Informal document GRSP-57-28
(57th GRSP, 18-22 May 2015,
agenda item 15)

**Proposal for Supplement 6 to the 06 series of amendments to
Regulation No. 16 (Safety-belts)**

**Submitted by the expert from the European Association of Automotive
Suppliers ***

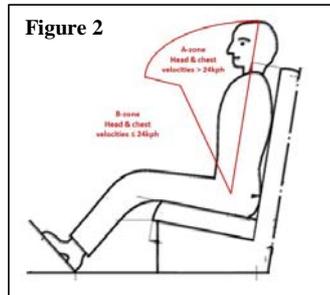
"12.1. In case a restraint system has been granted/refused/extended/withdrawn 2/ approval for general use, those can be used for all vehicles compatible with the following dimensional conditions: no interior part in a quoted A-zone as shown below (figure 2): *

Figure 1
Rear seats restraint system setup for dynamic test

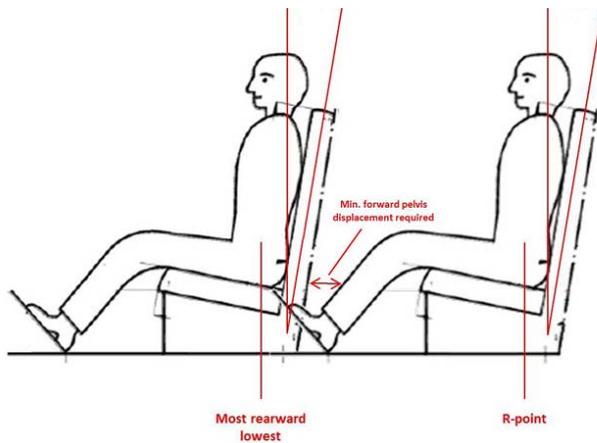
Insert a new Annex 19, to read:

"Annex 19

Rear seats restraint system setup for dynamic test

The seat in front of a tested seat shall be adjusted to the most rearward and lowest position appropriate for any contact with the manikin installed on the rear seat, then shifted forward for minimal pelvis displacement according to paragraph 6.4.1.3.2. and with a seat back angle at as close as possible to 10°, as derived from the 3-D H Point machine (Annex 19, Figure 1).
